**CITY OF SAINT PAUL
HERITAGE PRESERVATION COMMISSION STAFF REPORT**

FILE NAME: 1705 Summit Avenue, Louis A Weidenborner House

CLASSIFICATION: Building Permit #15-168470

B. PROPOSED CHANGES: The applicant proposes to:

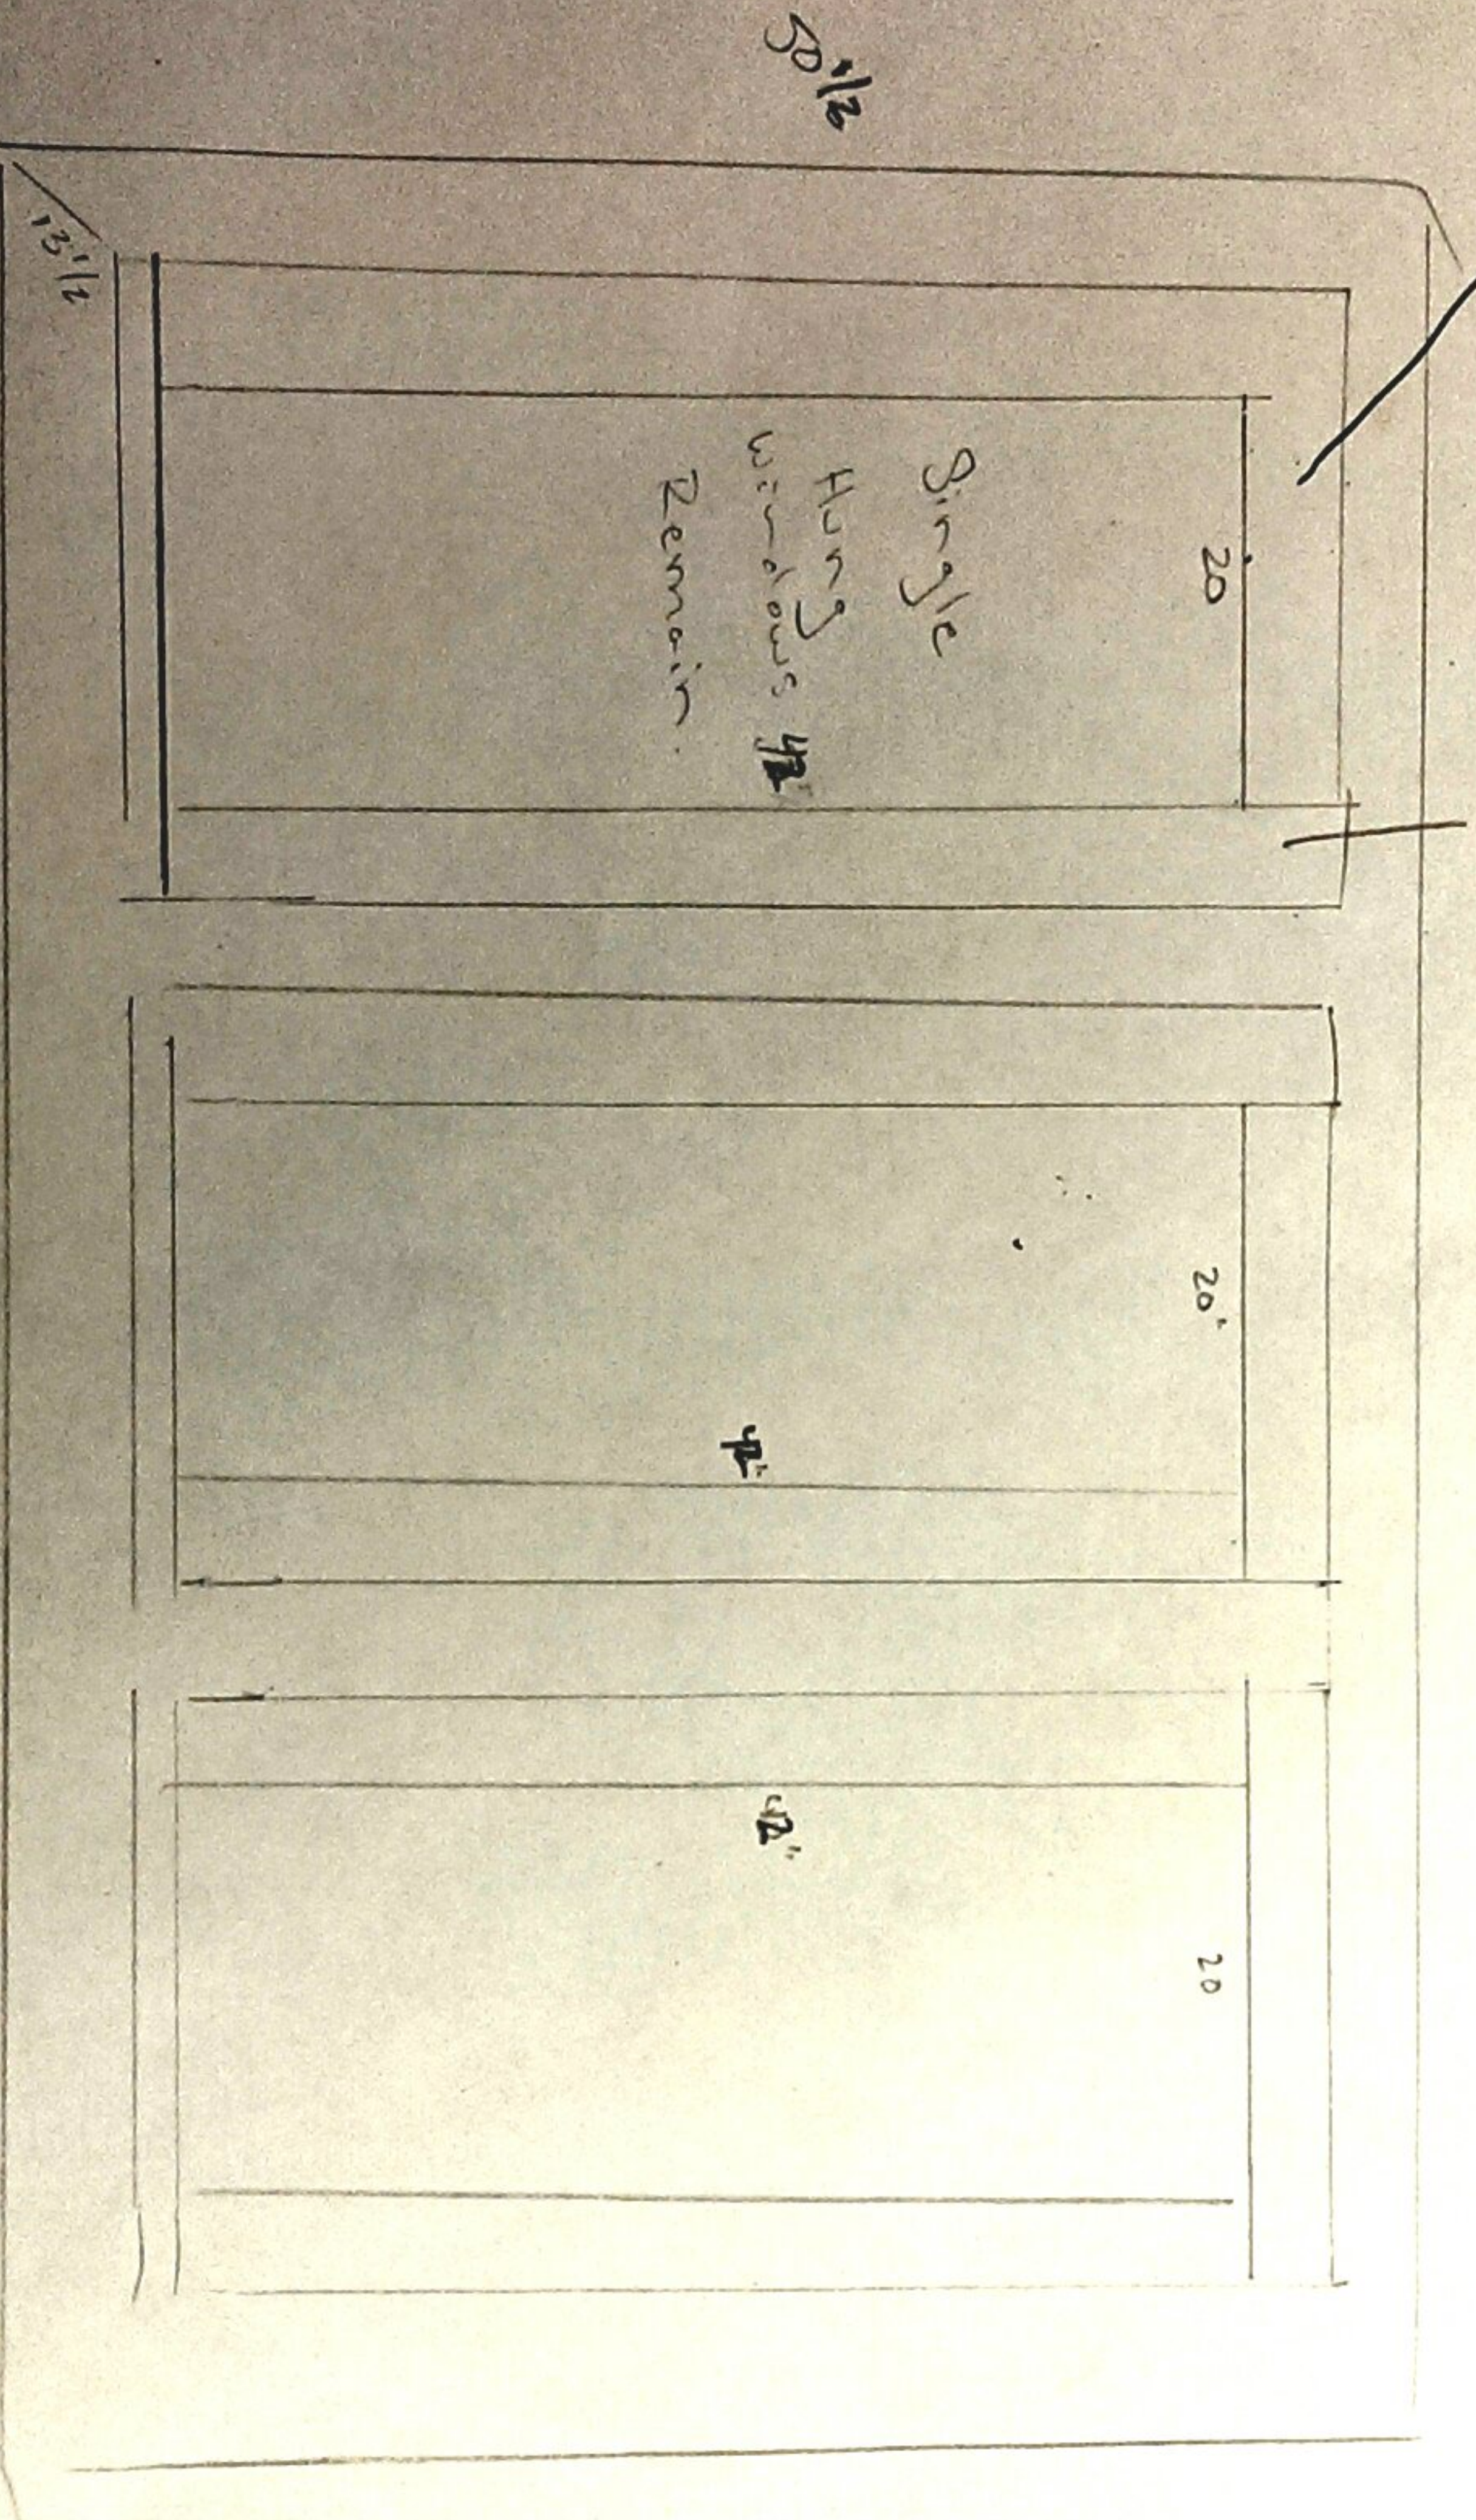
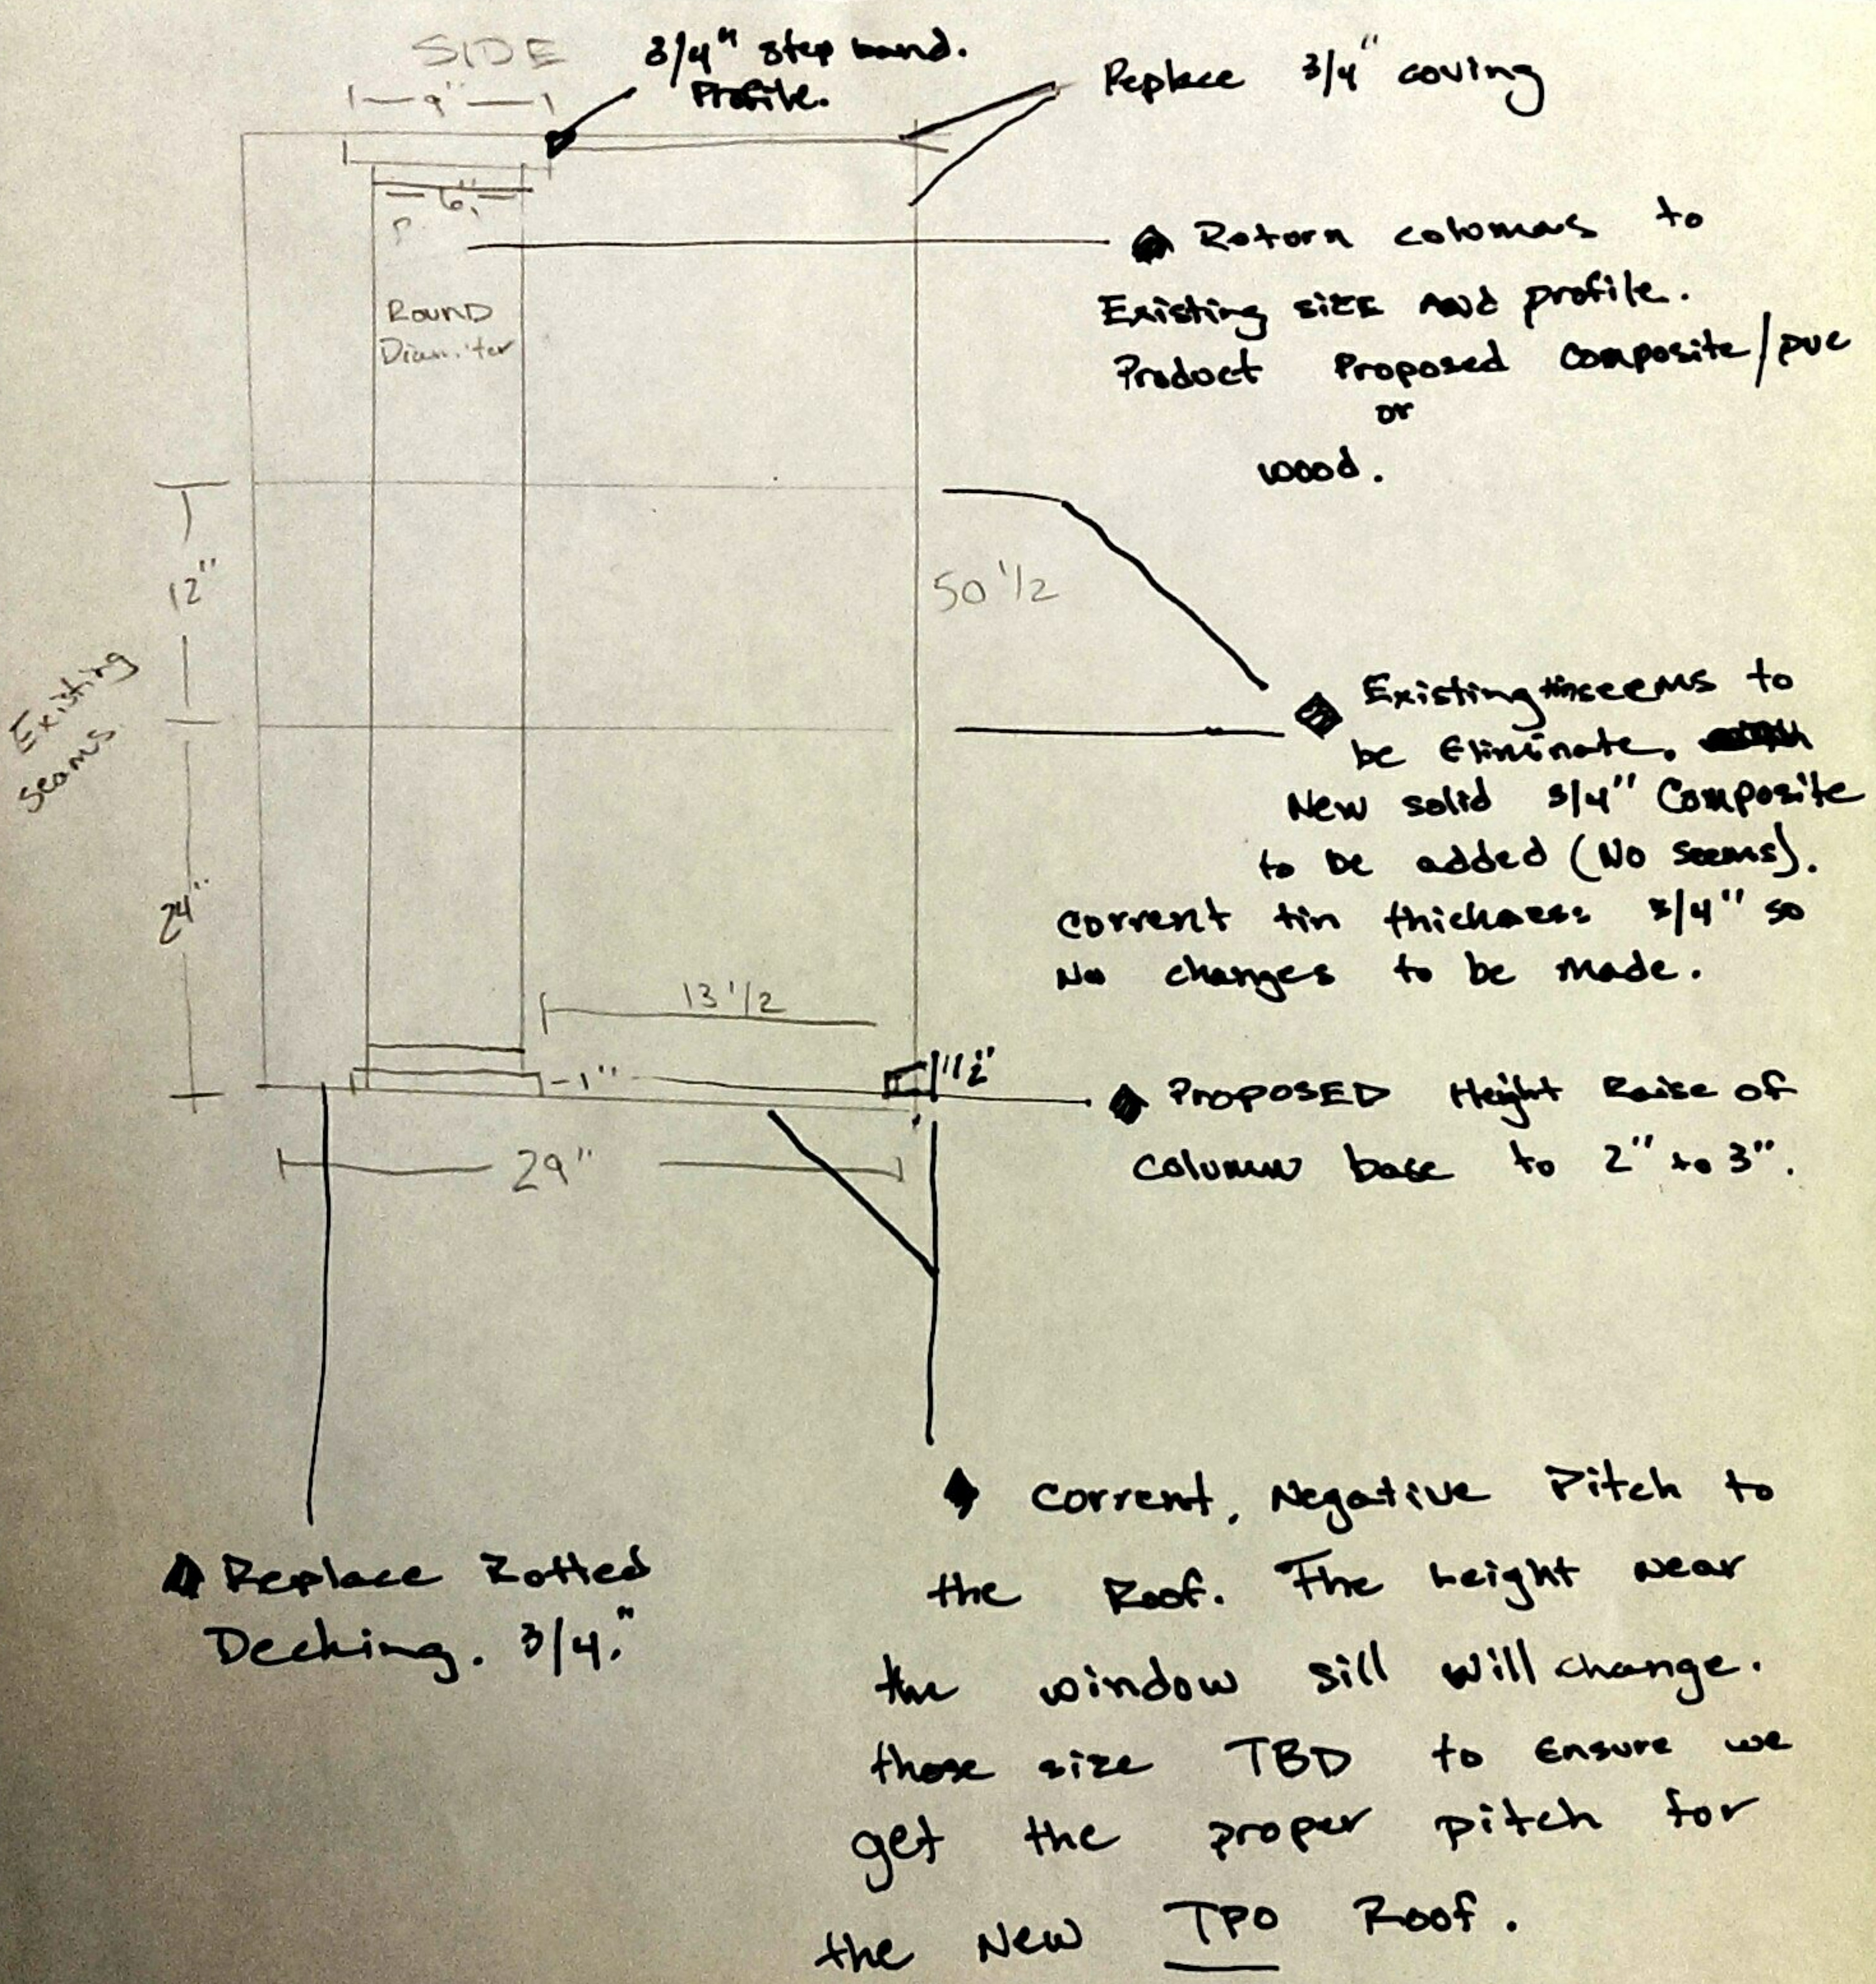
3. **Sec. 74.36.(a) (1)** The principle states, "removal or alteration of distinctive architectural features should be avoided." The National Register Nomination form specifically describes, "The main façade dormer has slender Tuscan columns with three rectangular windows deeply recessed behind them." The windows are no longer proposed for replacement, but the storm windows are proposed to be replicated with new wood storm windows; this complies with the principle. The wood columns are proposed to be replaced with composite columns that will be shorter due to a taller plinth, and the decorative moulding at the top and base are not shown in the plans. This alteration does not comply with the principle.

4. **Sec. 74.36.(a) (2) & Sec. 74.36.(e)(2)** "Decorative architectural features such as cornices, brackets, railings and those around front doors and windows should be preserved." All architectural elements and details inside and framing the dormer are proposed for replacement with the exception of the three, double-hung windows which are not included in the scope. The principle states, "deteriorated architectural features should be repaired rather than replaced whenever possible. In the event of replacement, new materials should match the original in composition, design, color, texture and appearance." The replacement of the metal floor and sidewalls with composite board does not comply with the principle, as it does not match the original in composition, design, color, or texture. The replacement of the wood columns and plinth with composite/PVC materials and in a different size and design, lacking the decorative moulding details present at the capital and base does not comply with the principle.

5. **Sec. 74.36.(a) (3)** "Distinctive stylistic features or examples of skilled craftsmanship characteristic of structures of a period should be treated sensitively." The wholesale replacement of the architectural elements of the front dormer does not comply with this principle.

Based on the findings, staff recommends denial of the application to replace the metal floors and sidewalls, wood columns and plinths, wood window trim/casings/sills, decorative wood trim and mouldings.

Staff could review and administratively approve an application for repair or in-kind replacement of the architectural elements of the dormer, allowing for the correction of the pitch of the floor which will slightly alter the size of the window sill and the height of the column.

6. **Sec. 74.36.(d) (3)** The guideline states, "Inappropriate new window and door features such as aluminum storm and screen window combinations, plastic or metal strip awnings, or fake shutters that disturb the character and appearance of the building should not be used. Combination storm windows should have wood frames or be painted to match trim colors." The proposal to replace the three, historic wood storm windows with new wood storm windows with the same size and detail complies with this guideline.

Based on the findings, staff recommends approval of the application to replace the three, historic, wood storm windows in-kind.
